RESPONSE TO CEC STAFF DATA REQUEST SET 1 (1-30)

CA3 Backup Generating Facility (21-SPPE-01)

SUBMITTED TO: CALIFORNIA ENERGY COMMISSION

SUBMITTED BY: Vantage Data Centers

Generator Schematic with DEF Tank and Secondary Containment

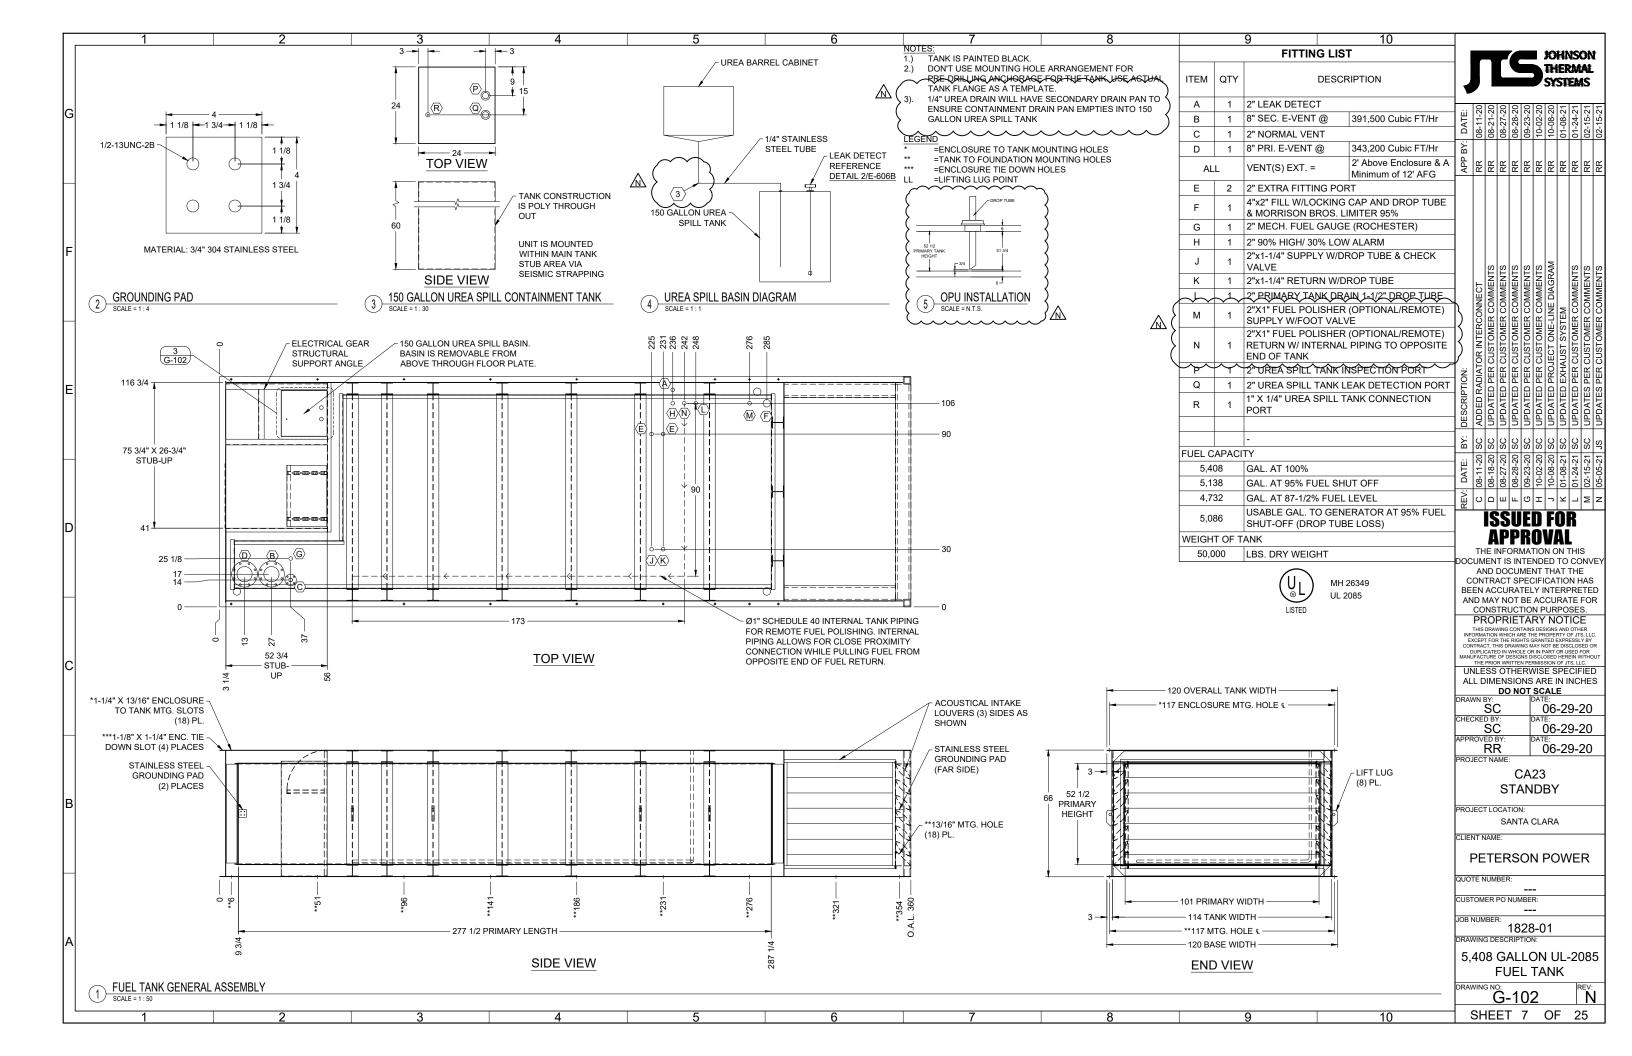
12. Please provide a schematic showing if the DEF is in a secondary containment.

RESPONSE TO DATA REQUEST 12

Substation and Transmission Line Drawing

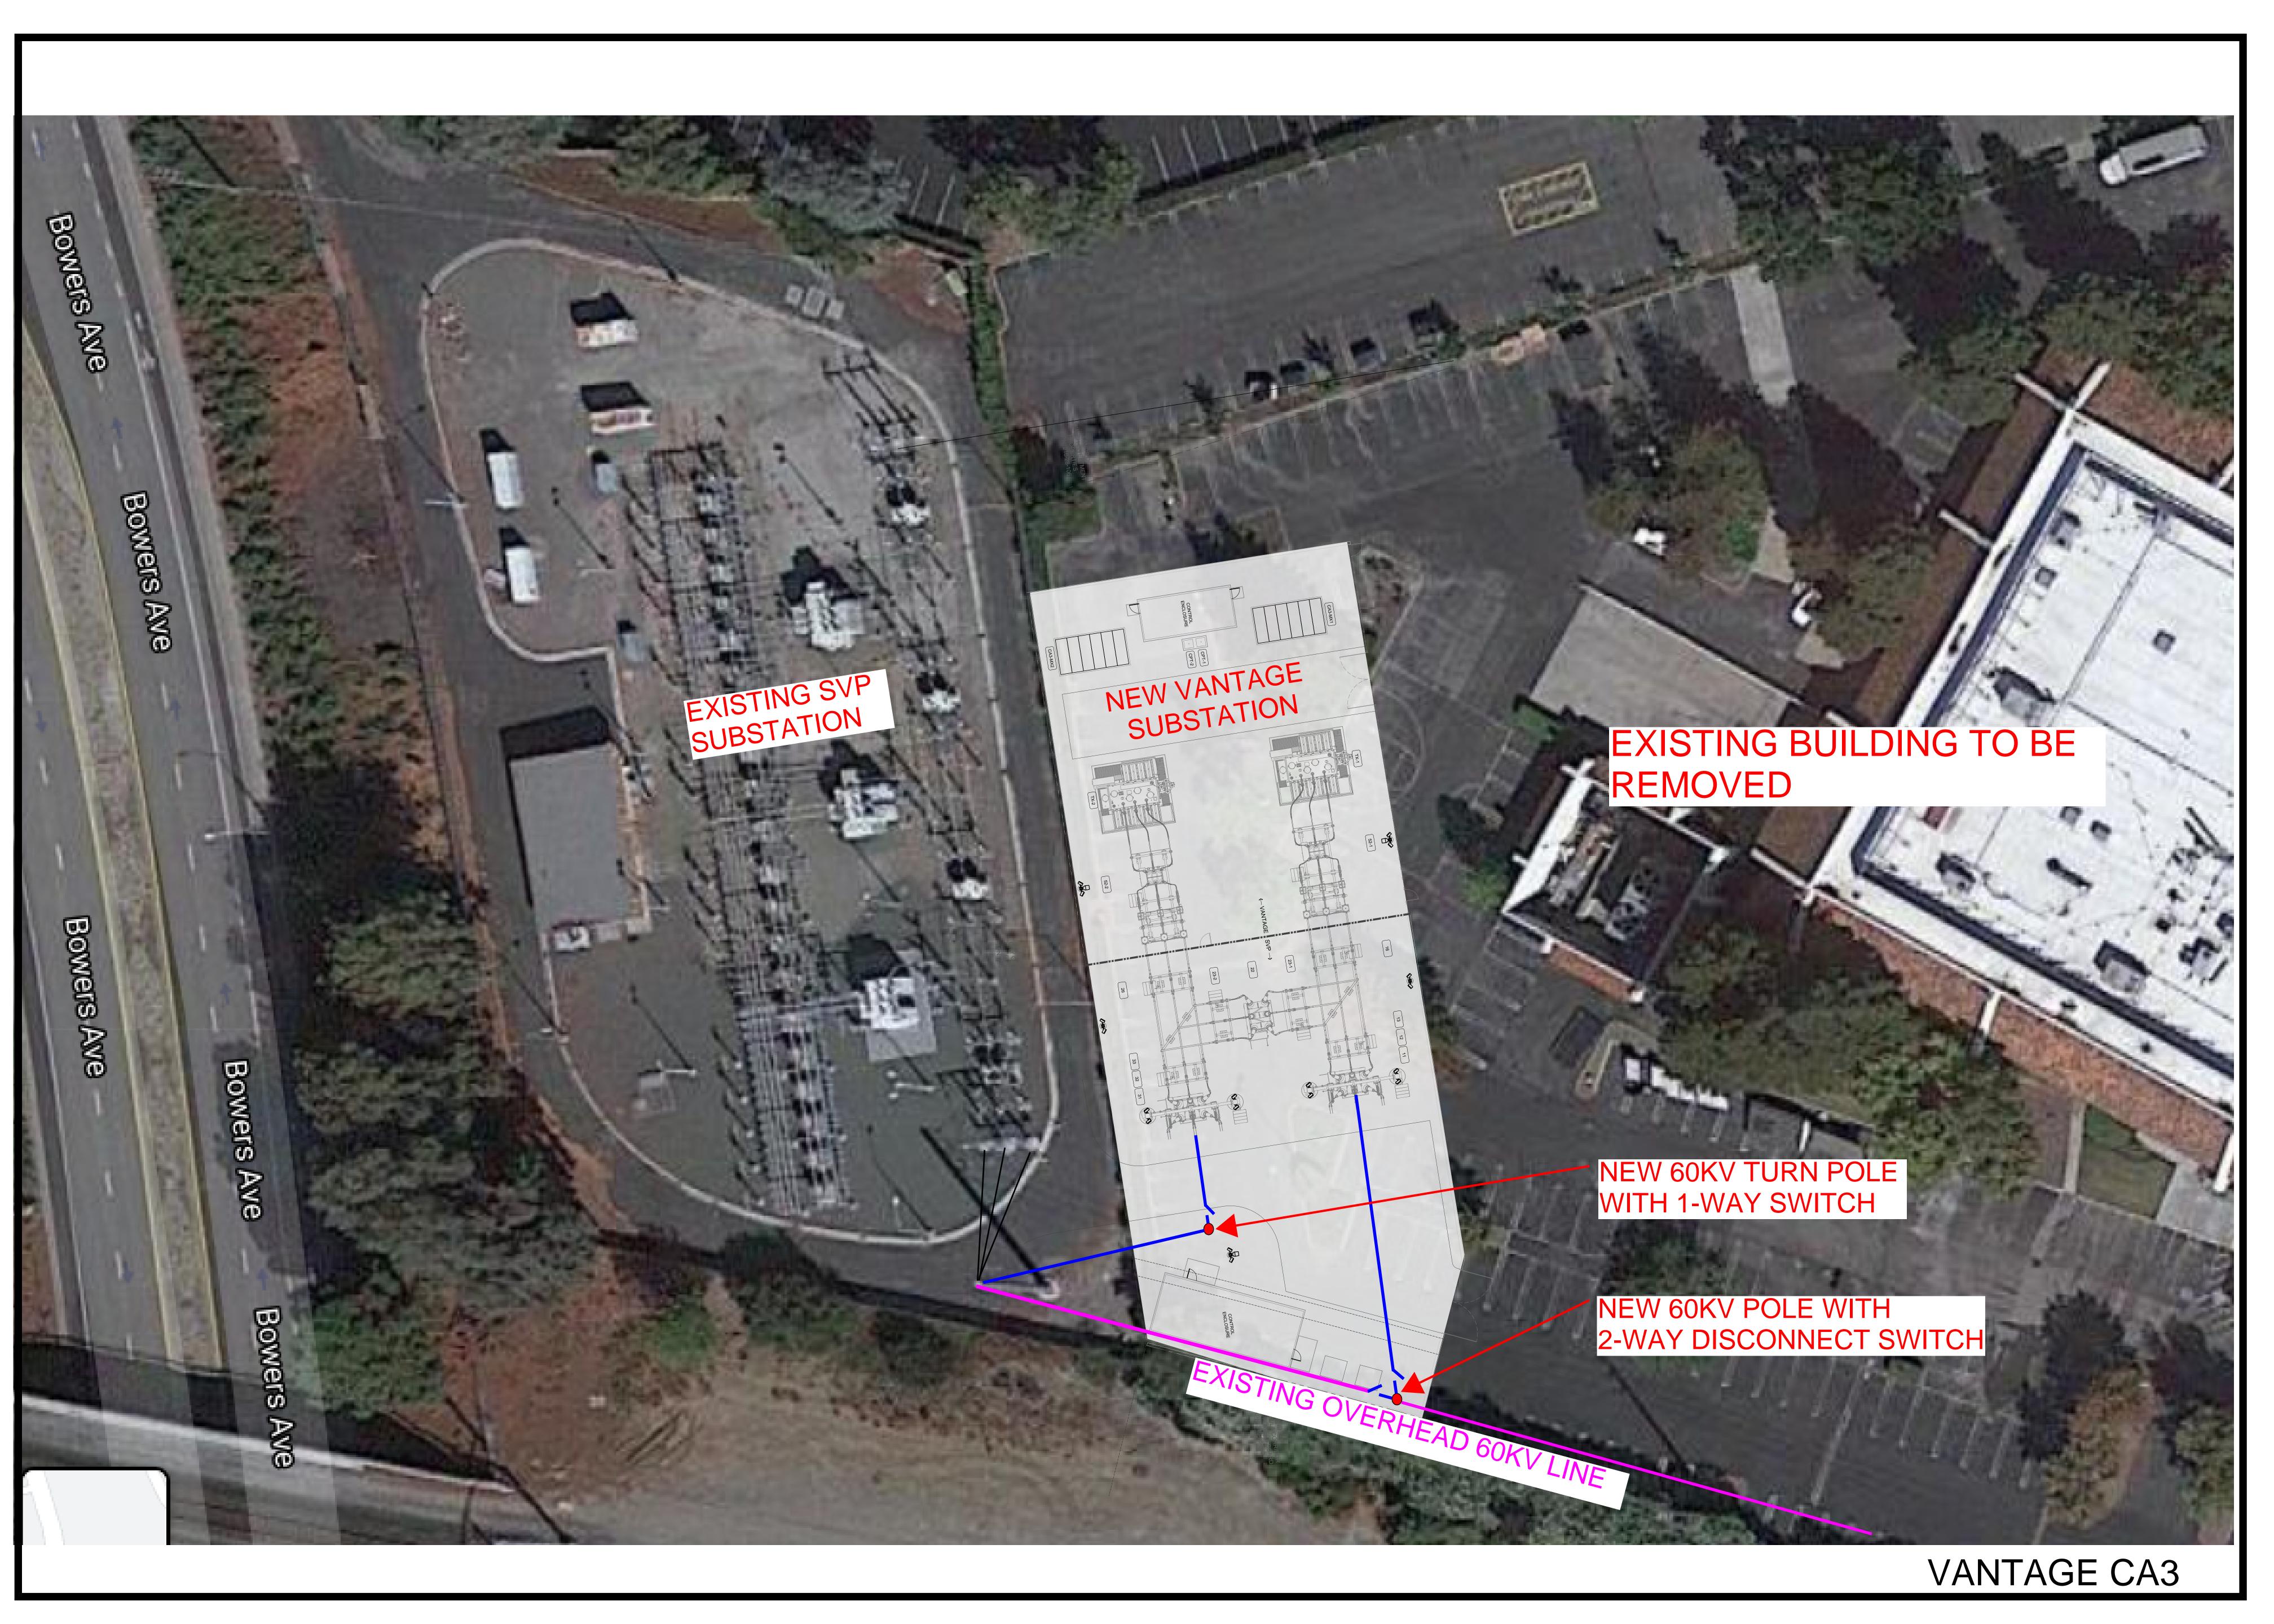
13. Please provide a detailed description and drawing of the proposed 60 kilovolt (kV) transmission line route, length, possible interconnection points to the existing SVP system, and possible pole locations. Please provide a legend and label the drawing to show the proposed line route, pole locations, and the existing transmission facilities.

Please see Attachment PD DR-13.
